MANDATORY SERVICE BULLETIN**NUMBER:** SB13-06**REVISION:** 00**DATE:** June 8, 2013**SUBJECT:** TEN THOUSAND HOUR LIFE EXTENSION FIELD RETROFIT**EFFECTIVITY:**

The accompanying Field Service Instruction provides guidance for installing the structural upgrades required to extend the aircraft service life of the KODIAK 100 to 10,000 hours.

FIELD SERVICE INSTRUCTION

Ten Thousand Hour Life Extension Field Retrofit

Figure 5-2: Detail View of Figure 5-1 (Left Side) With Fairing Removed

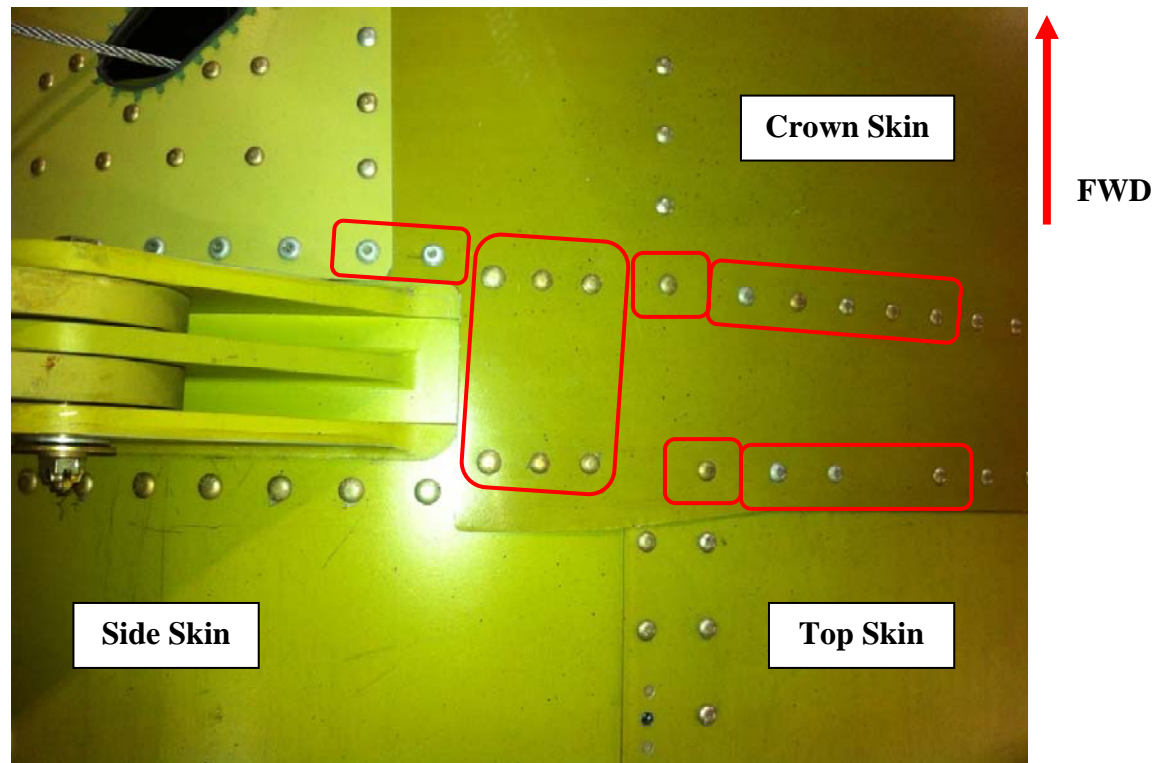
1. Drill out the rivets shown in the **Figure 5-2**.

2. Correctly position the shims (P/N 100-935-0917, 100-210-4012, and 100-935-1038) as shown in **Figure 5-2** through **Figure 5-5**, and backdrill to match existing rivet holes.
3. Remove and deburr shims.
4. Install the shim (P/N 100-935-0917) in the location indicated in **Figure 5-3** and **Figure 5-4** using rivets (P/N CR3213-5). Shim is to fill the skin lap gap between the crown skin and frame.
5. Install the shim (P/N 100-210-4012) in the location indicated in **Figure 5-3** using rivets (P/N MS20470AD5) in the two outboard holes, and rivets (P/N MS20470AD4) in the four inboard holes. The shim is to fill the skin lap gap between the crown skin and side skin.

Figure 5-4: View Looking Aft and Up Inside Cabin at Forward Carrythru Frame

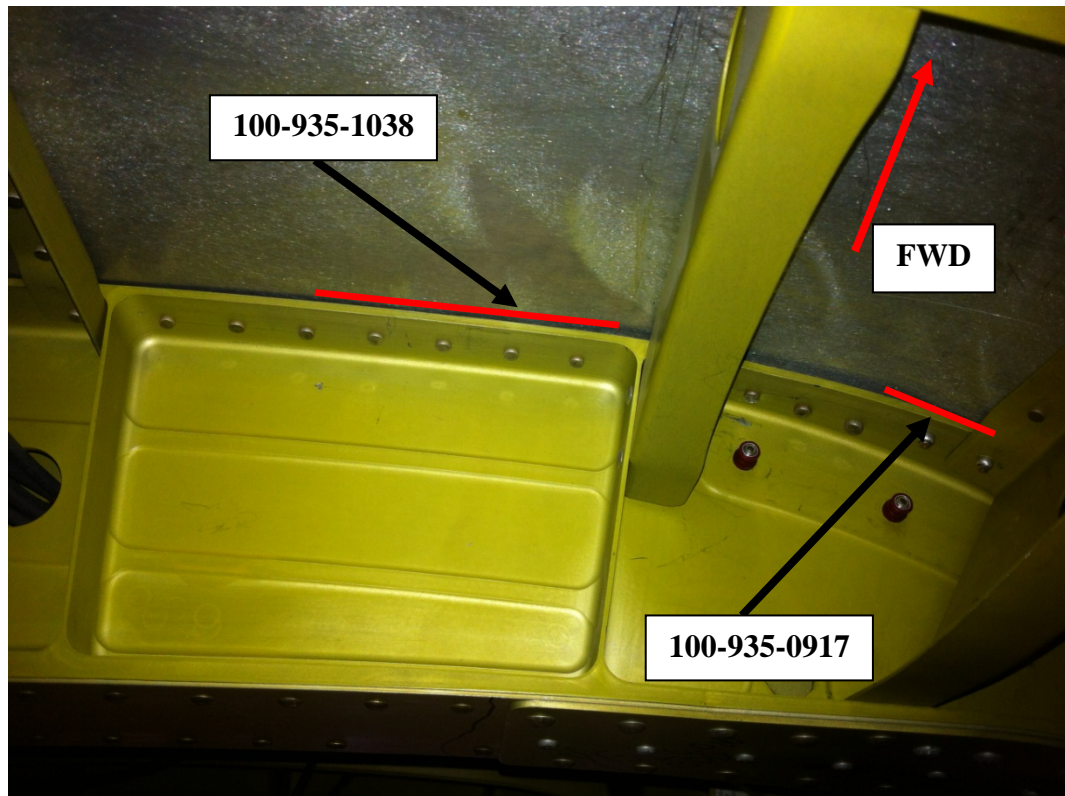
6. Install the shims (P/N 100-935-1038) in the locations indicated in **Figure 5-4** and **Figure 5-5** using rivets (P/N MS20470AD4). The shim is to fill the skin lap gap between the top skin and frame.
7. Inspect between the crown skin and top skin in the four (4) locations where the shims (P/N 100-935-1038) have been installed:
 - a. If a gap of less than or equal to 0.032" exists between the crown skin and the top skin, proceed to **Step 8**.
 - b. If a gap greater than 0.032" exists between the crown skin and the top skin, fabricate a tapered shim to fill the gap to within 0.010". The shim material is to be 2024-T3. Acid etch, alodine, and prime shim per AC 43.13-1B, Chapter 6.

Figure 5-6: View Looking Down on Hi-Lok Locations

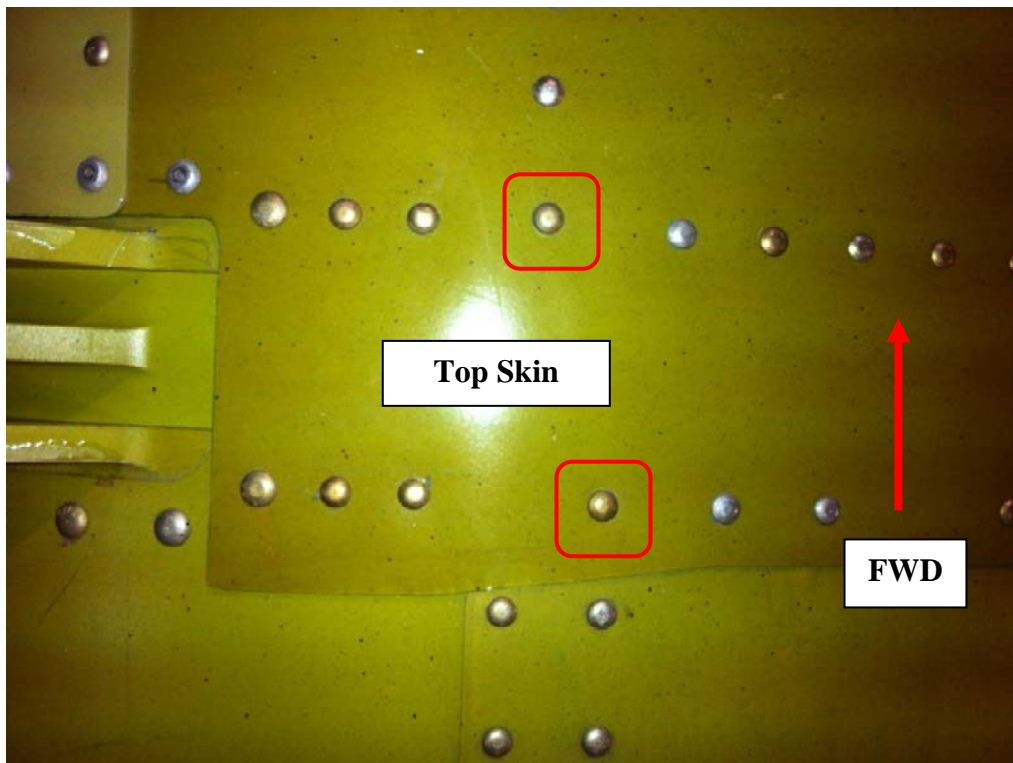
8. Up-size the holes identified in **Figure 5-6** to 0.1610" – 0.1640" (#24 drill bit and 0.1610 reamer).
9. Install Hi-Lok pins (P/N HL20PB5-5) and Hi-Lok collars (P/N HL86-5) in the forward location,
10. Install Hi-Lok pins (P/N HL20PB5-4) and Hi-Lok collars (P/N HL86-5) in the aft location.

Figure 5-7: View of General Clip Location

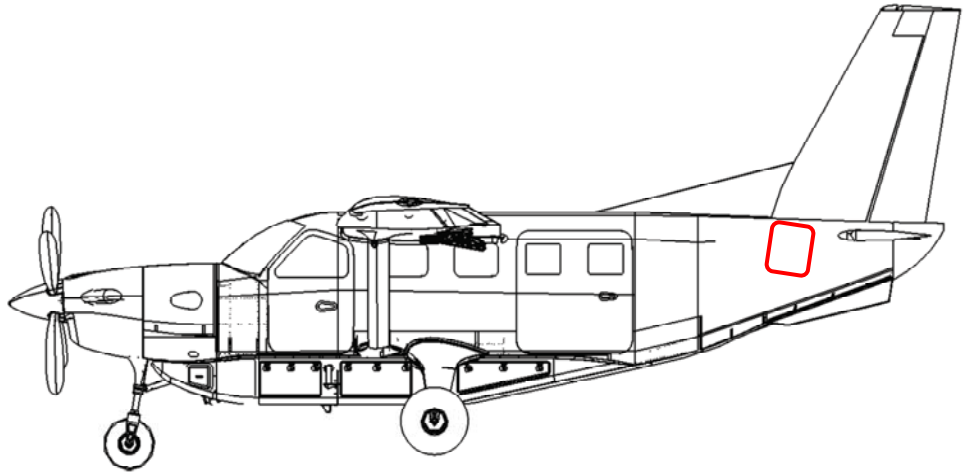
1. Inspect the rivets holding the left and right shear clips to the adjacent stringer, as shown in **Figure 5-7** through **Figure 5-9**.

Figure 5-9: Close-Up Showing Location of the Rivets to be Replaced

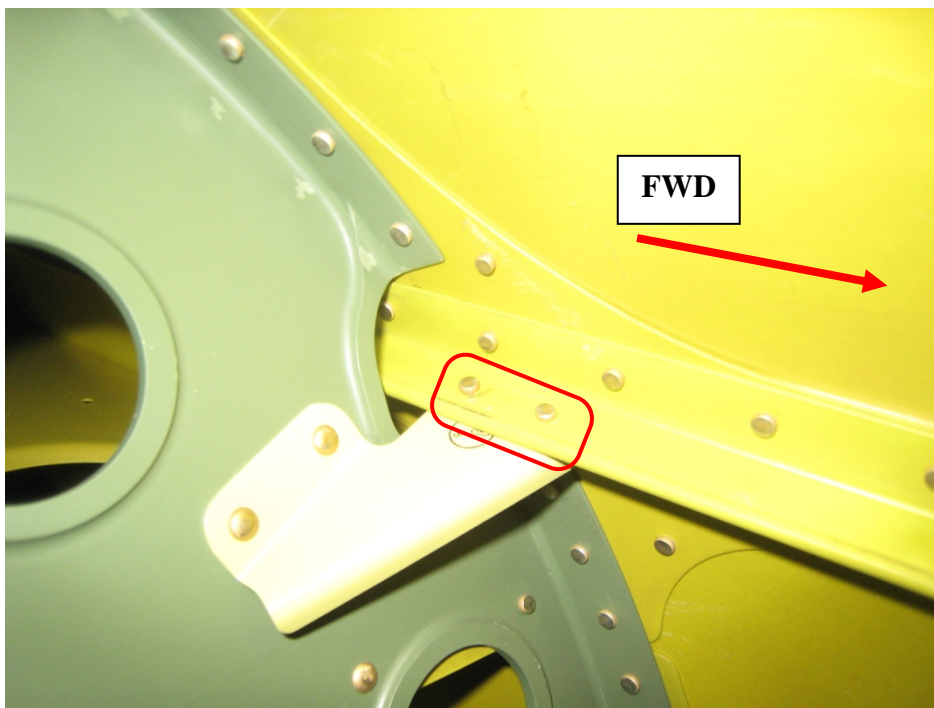
2. If the rivets are MS20470AD4 solid rivets, the installation is acceptable; proceed to **Section 5.3**; if CherryMAX blind rivets are installed, proceed with the following steps:
3. Remove the rivets holding each shear clip to the adjacent stringer.

4. Up-size each hole to 0.1610" – 0.1640" using a #24 drill bit and 0.1610" reamer (#20).
5. Inspect each hole to verify a minimum distance of 0.25" from the center of the hole to the edge of the stringer flange.
 - a. If this minimum edge distance is not maintained, contact Quest for further instructions.
6. Install Hi-Lok fasteners (P/N HL18PB5-2) and Hi-Lok collars(P/N HL82-5AW) in each hole with the collar facing up.
 - a. If a Hi-Lok collar will not sit flush, install shim (P/N 100-240-2017) using Hi-Lok fasteners (P/N HL18PB5-4) and Hi-Lok collars (P/N HL82-5AW). Clamp the shim in place, nested on the stringer flange under the Hi-Lok collar, such that the fastener hole is centered in the shim, backdrill, and ream to match.
